DREDGED MATERIAL MANAGEMENT PLAN AND ENVIRONMENTAL IMPACT STATEMENT

McNary Reservoir and Lower Snake River Reservoirs

APPENDIX A Hydrologic Analysis

**ERRATA SHEET
FOR
APPENDIX A - HYDROLOGIC ANALYSIS**

LOWER GRANITE LOCK AND DAM
SNAKE RIVER, WASHINGTON
AND IDAHO
SEDIMENTATION RANGES
CLEARWATER RIVER - INDEX
U. S. ARMY ENGINEER DISTRICT
WALLA WALLA

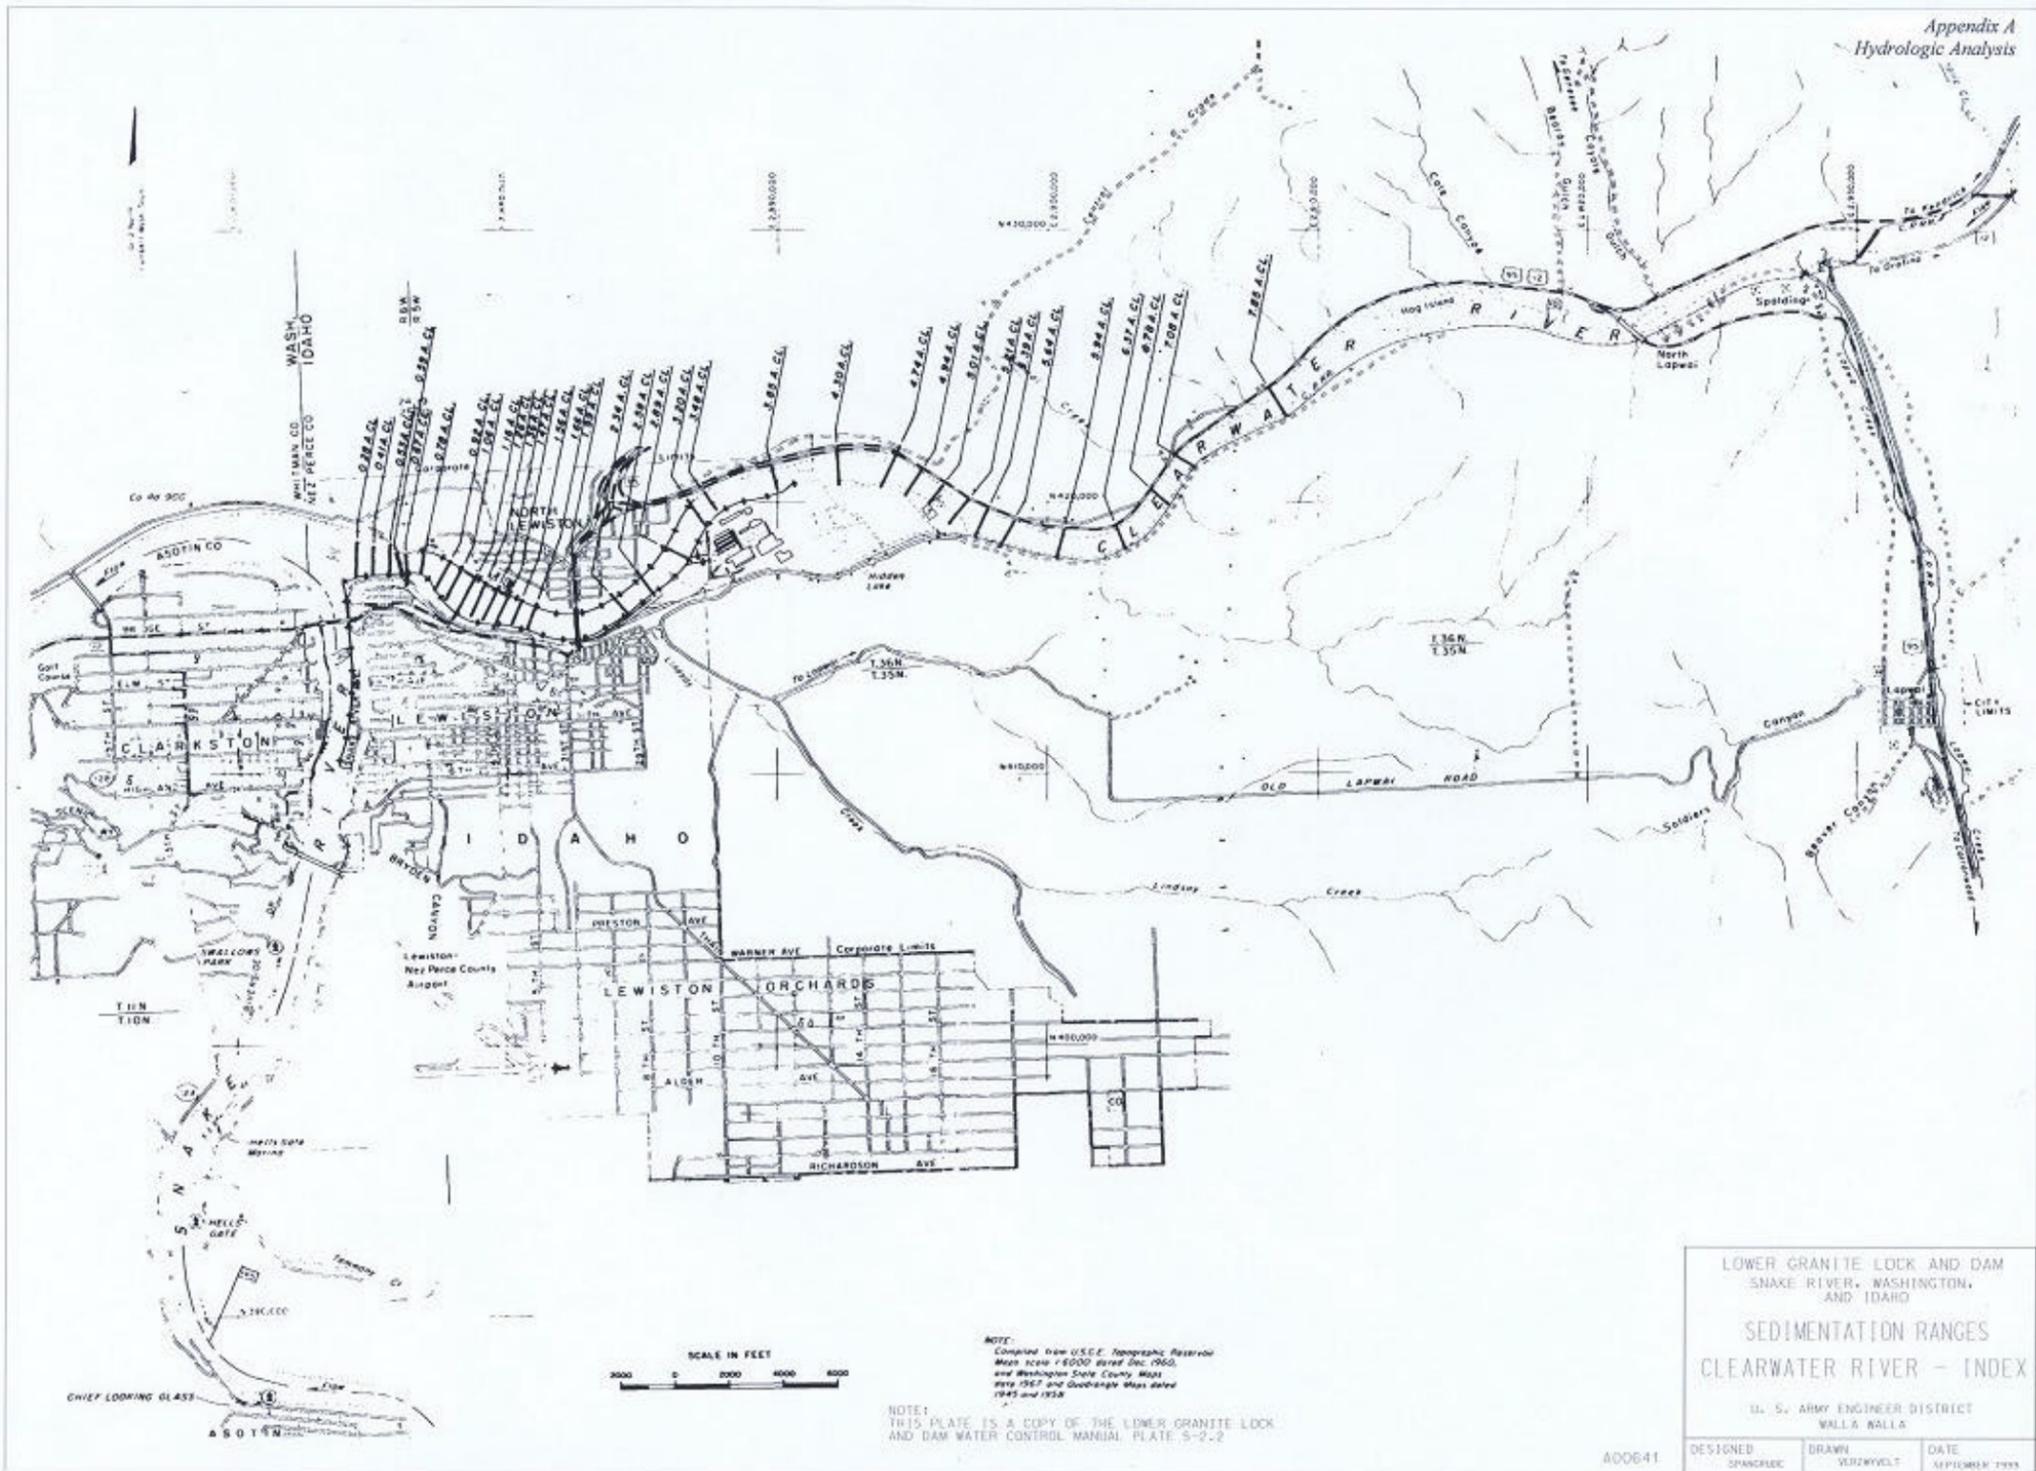
Title of Plate 6 should be: Clearwater River in Lower Granite Reservoir Sedimentation Ranges

MCNARY LOCK AND DAM COLUMBIA RIVER, OREGON, WASHINGTON		
SEDIMENTATION RANGES INDEX SHEET		
U. S. ARMY ENGINEER DISTRICT WALLA WALLA		
DESIGNED SPANDRUBE	DRAWN VERZNYVELT	DATE SEPTEMBER 1999
PLATE 7

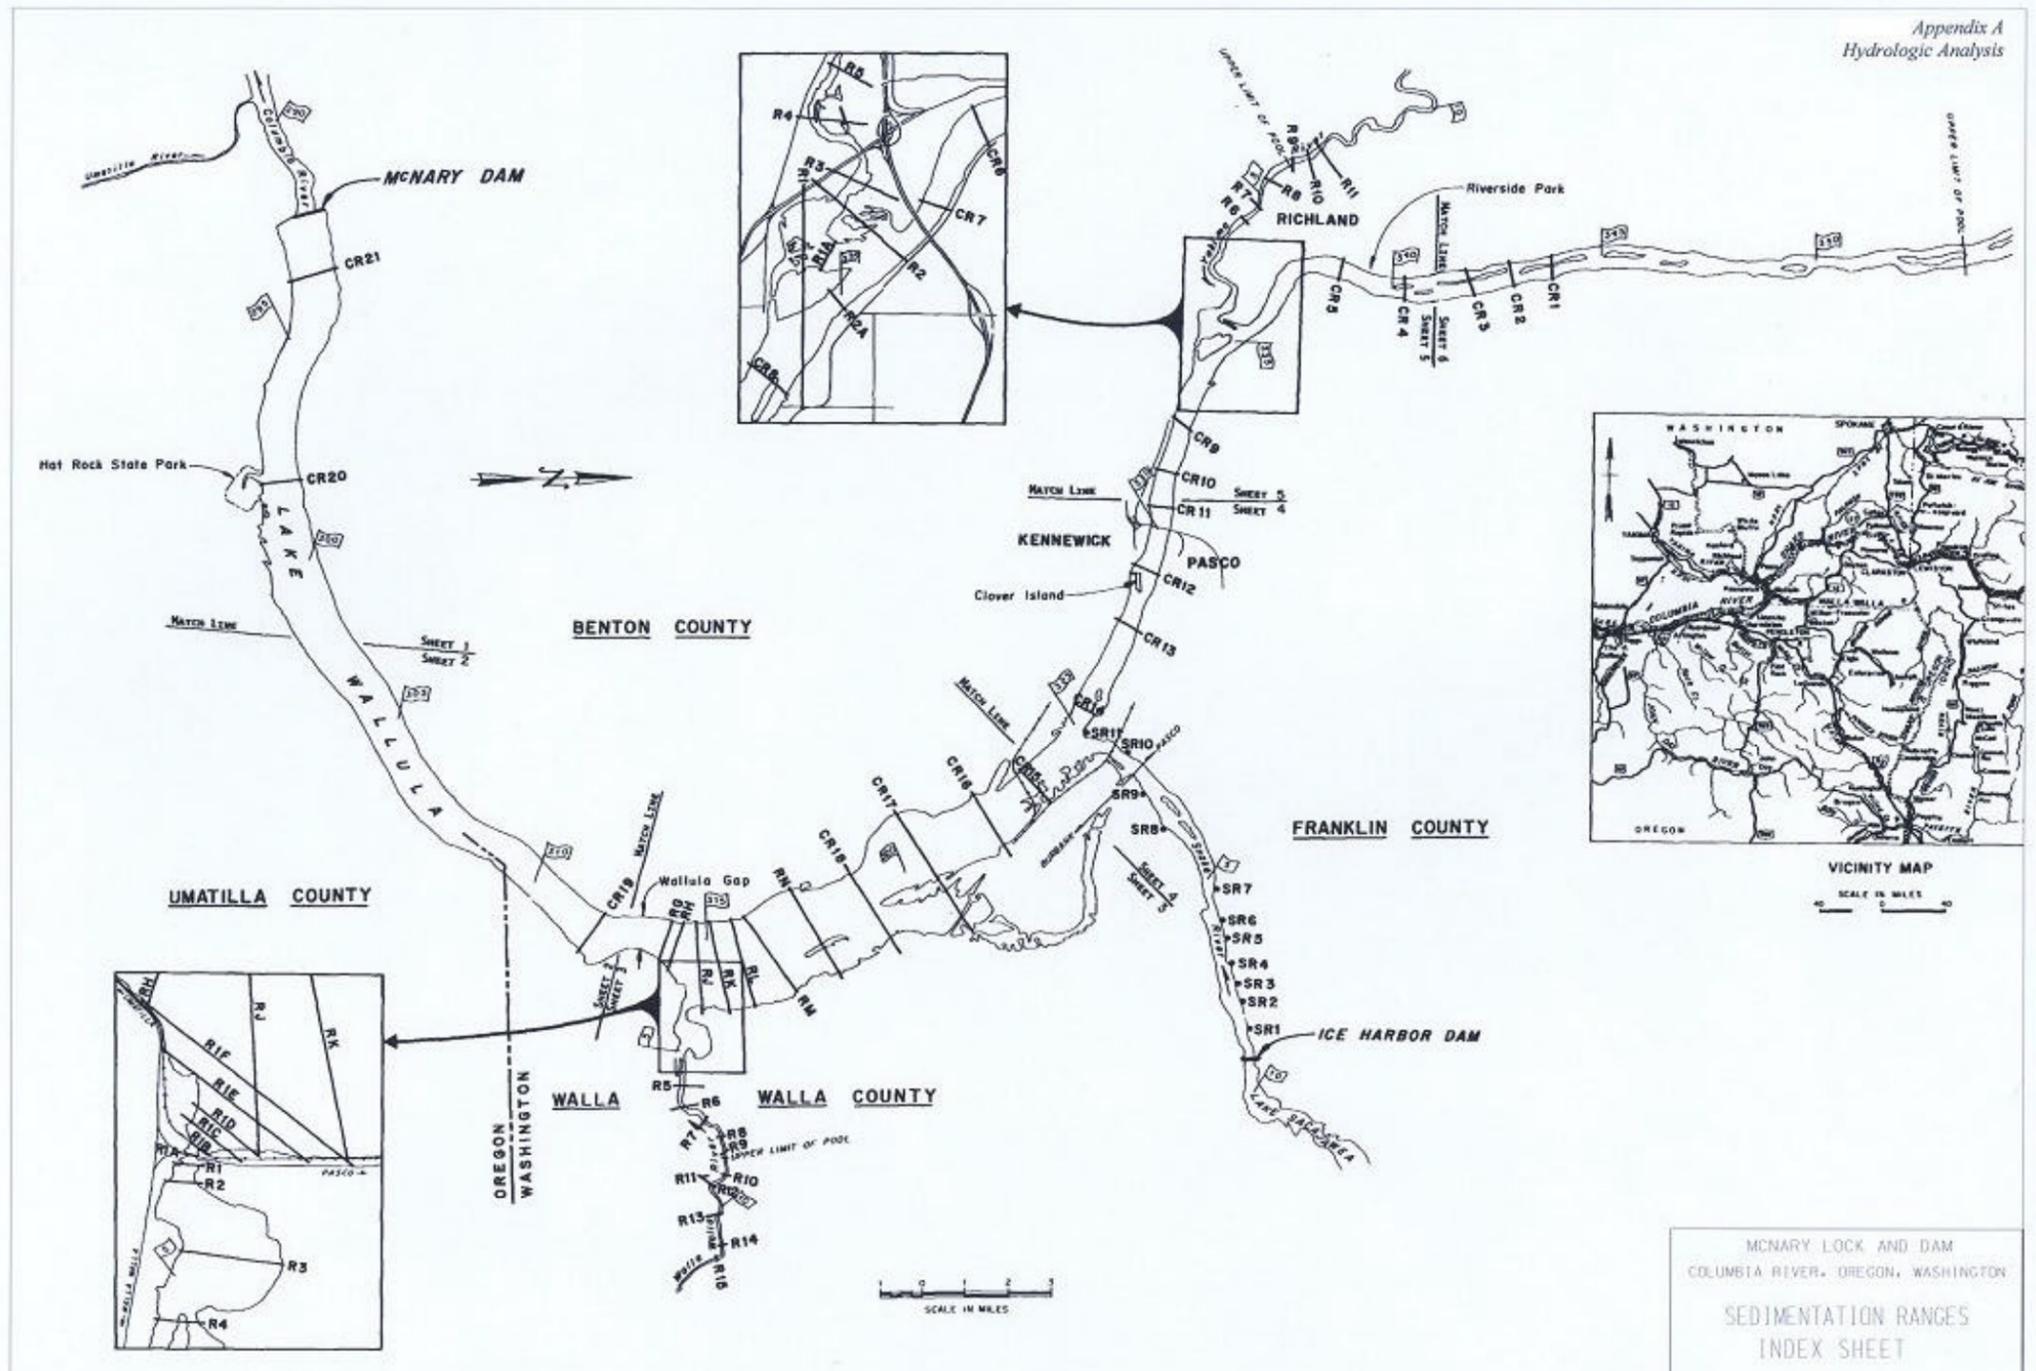
Title of Plate 7 should be: Columbia River in McNary Reservoir Sedimentation Ranges
